HOUSE LOCATION PLAT

CLARKSVILLE MANOR

Addendum:

6308 Morning Dew Court

5 BR P6-
SITE PLAN

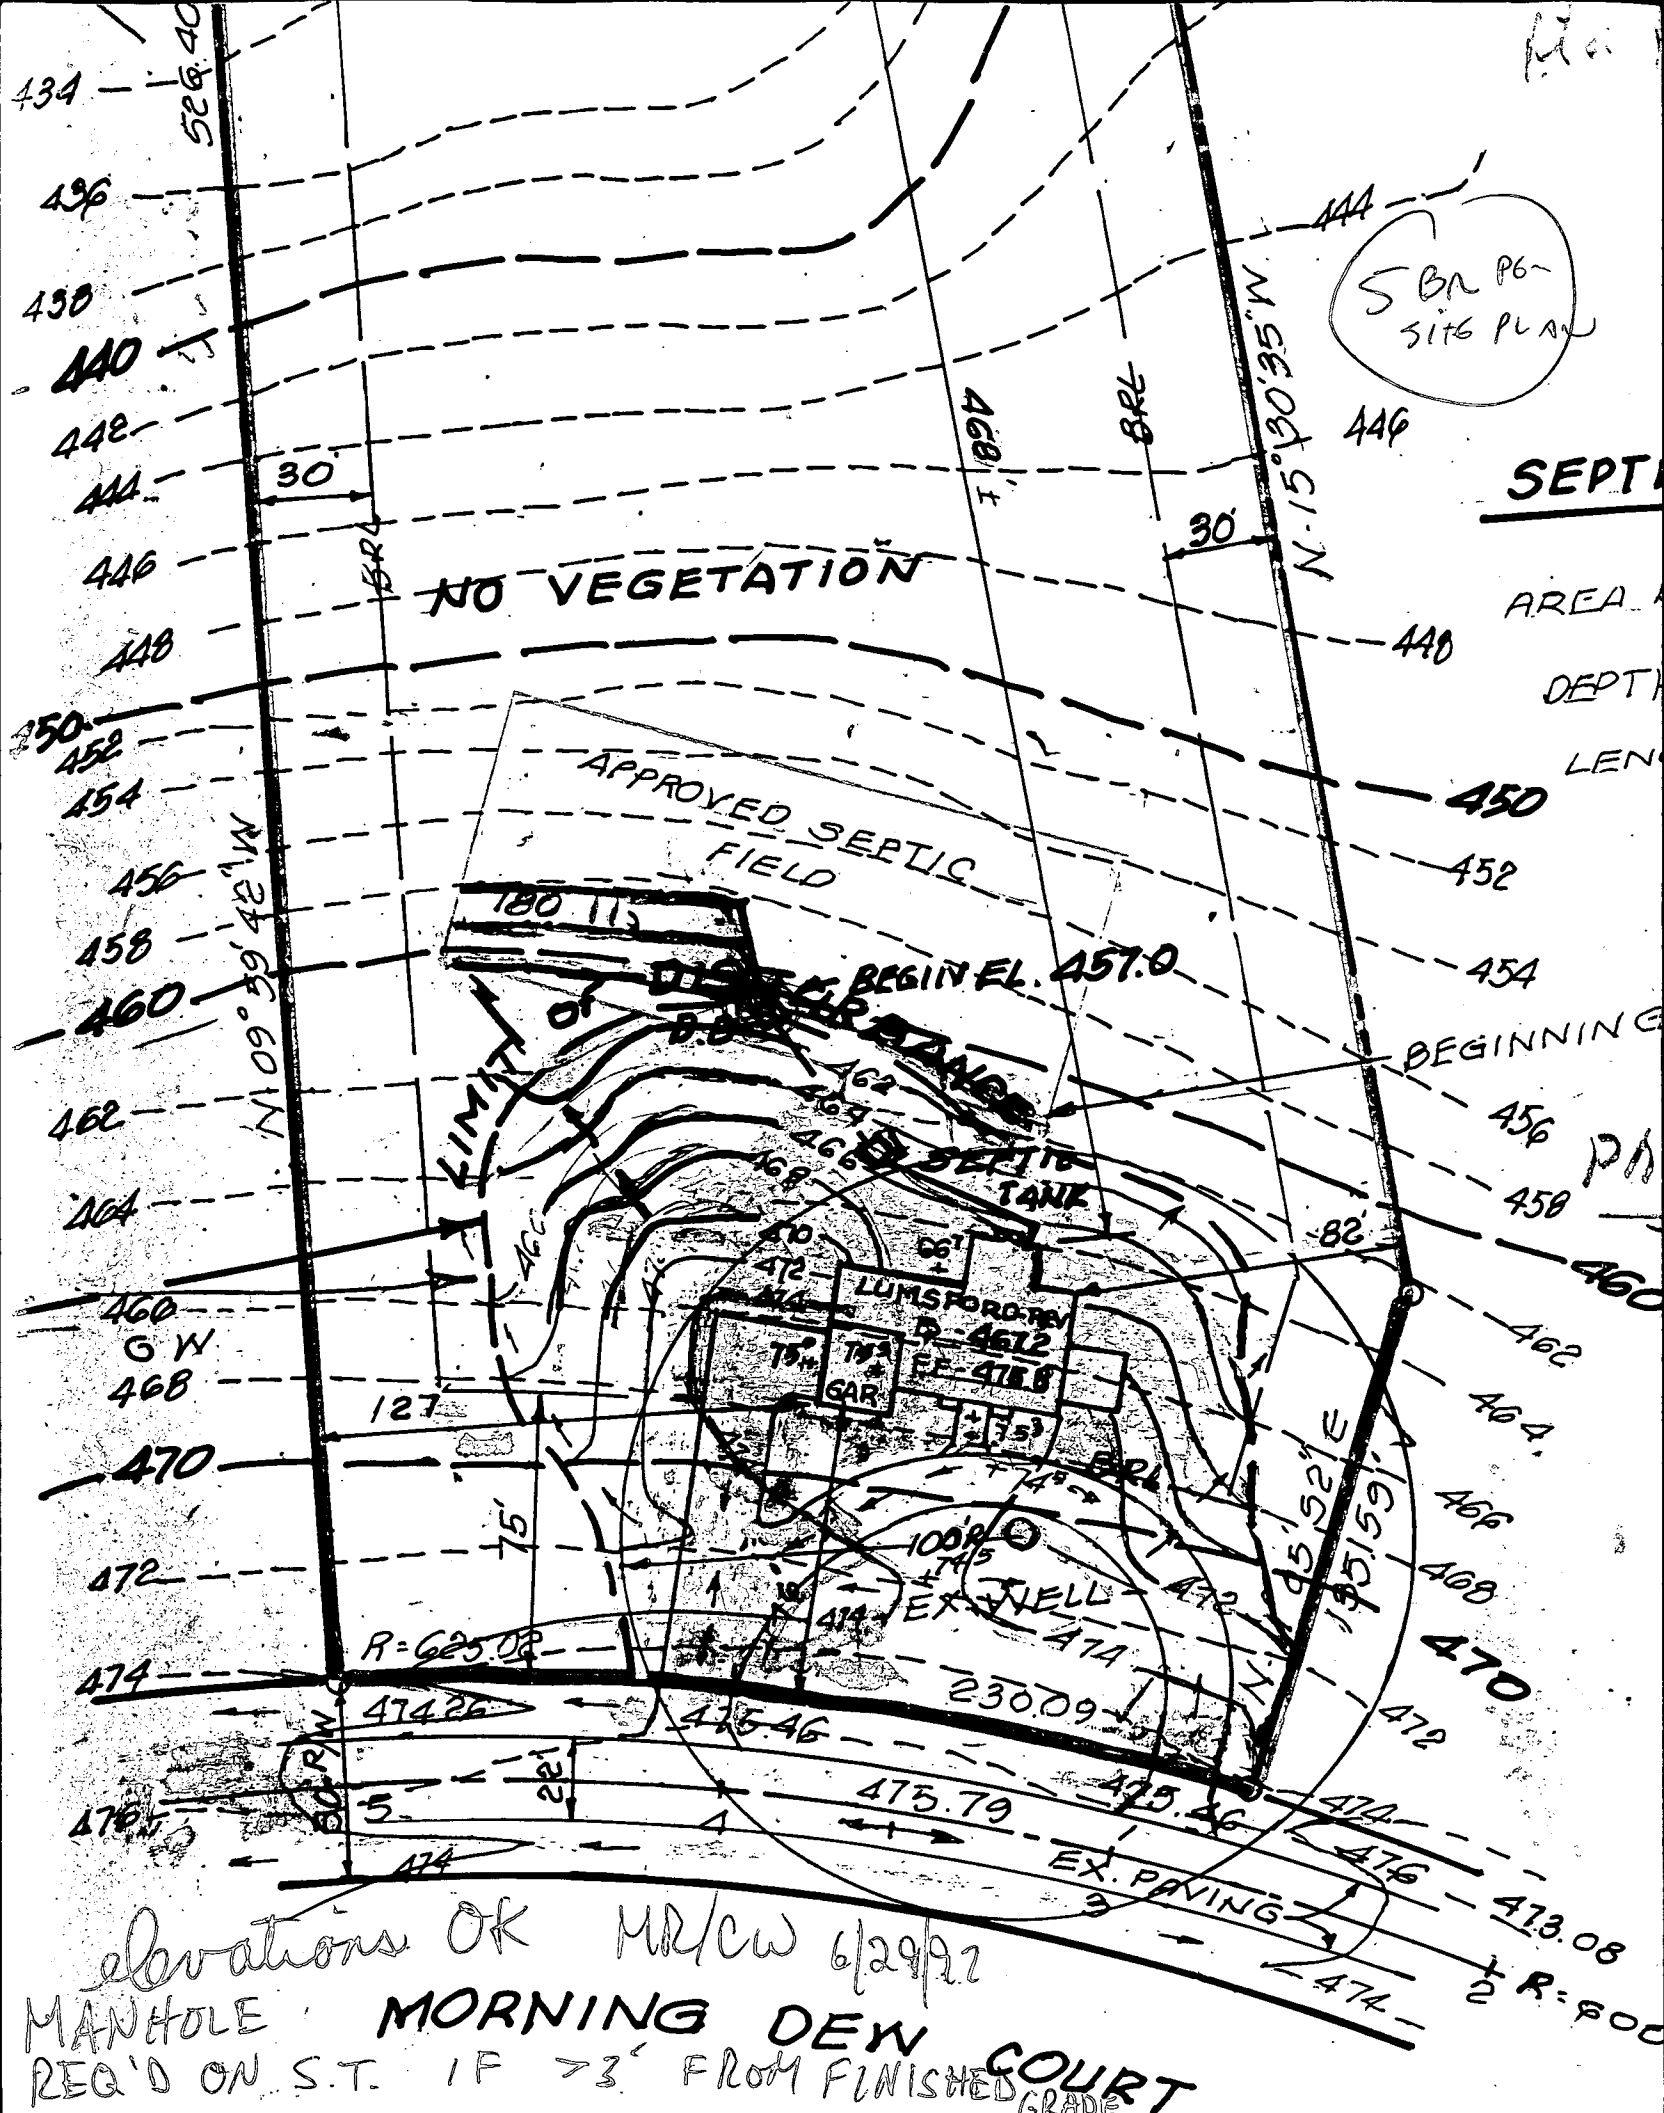
elevations OK MR/CW 6/29/92
MANHOLE MORNING DEW COURT
REQ'D ON S.T. IF > 3' FROM FINISHED GRADE

HOUSE LOCATION PLAT

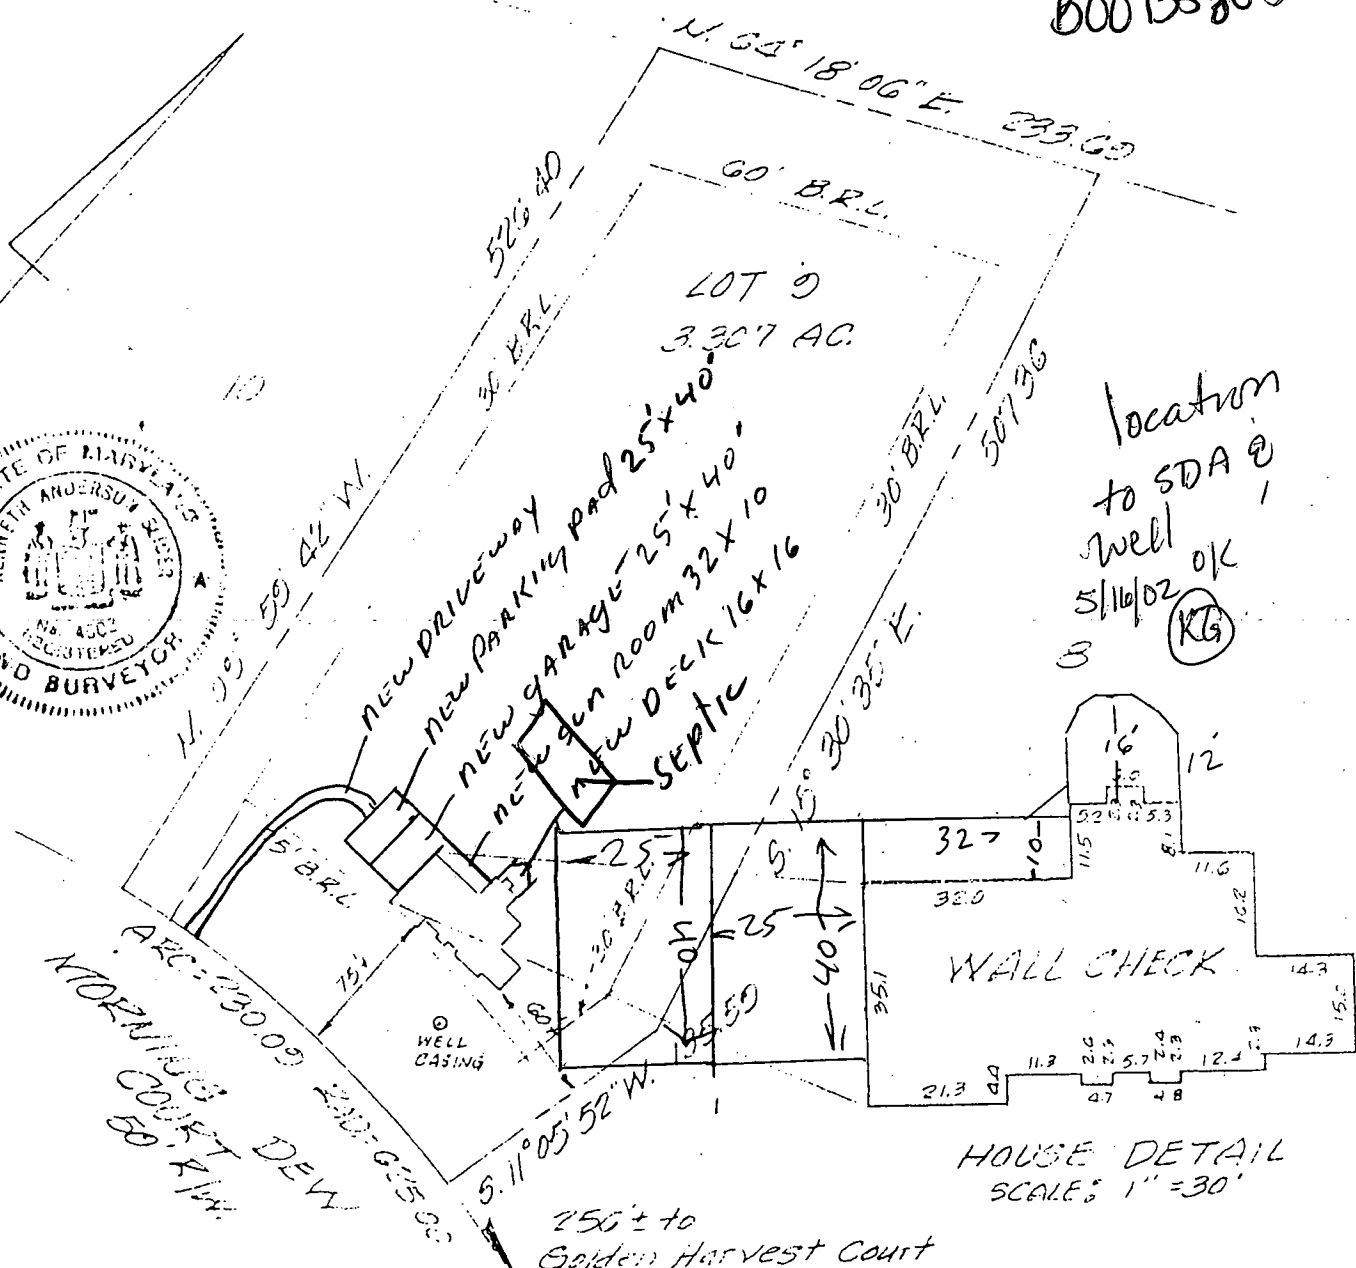
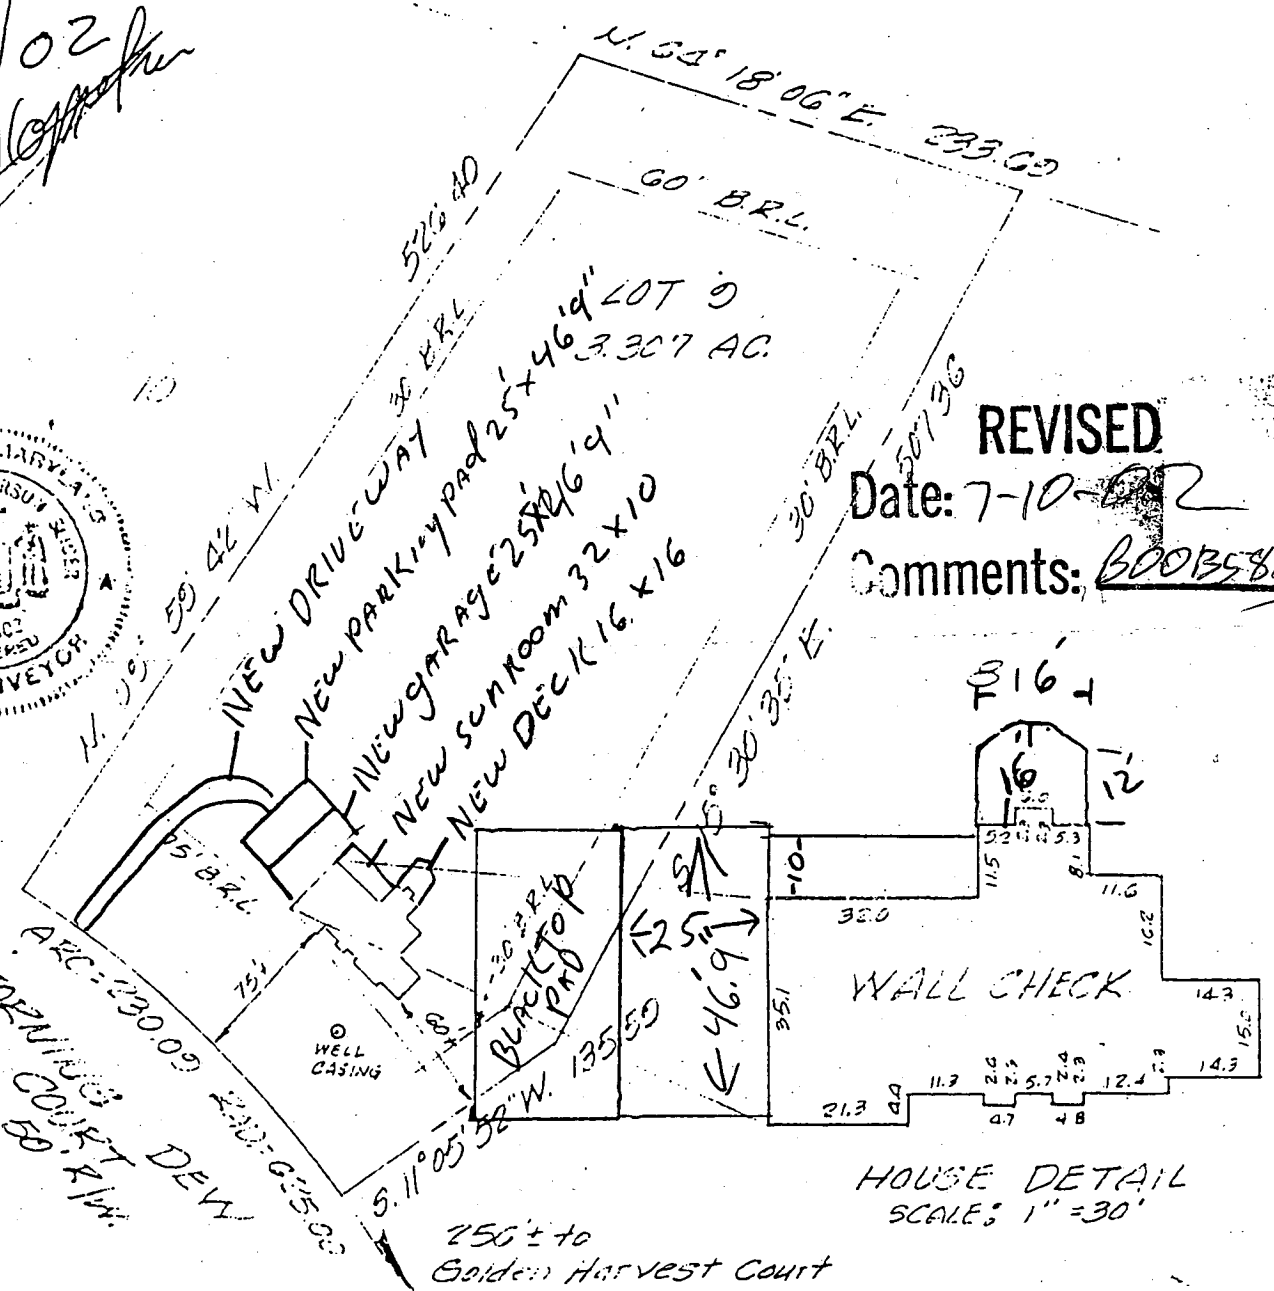
Extend garage to 46 ft. 9 inches from the original plans that show forty feet. Extend black top pad also 46 ft, 9 inches.

Note new date on revised plot plan.

REVISED
 Date: 7-10-02
 Comments: BOOB5823
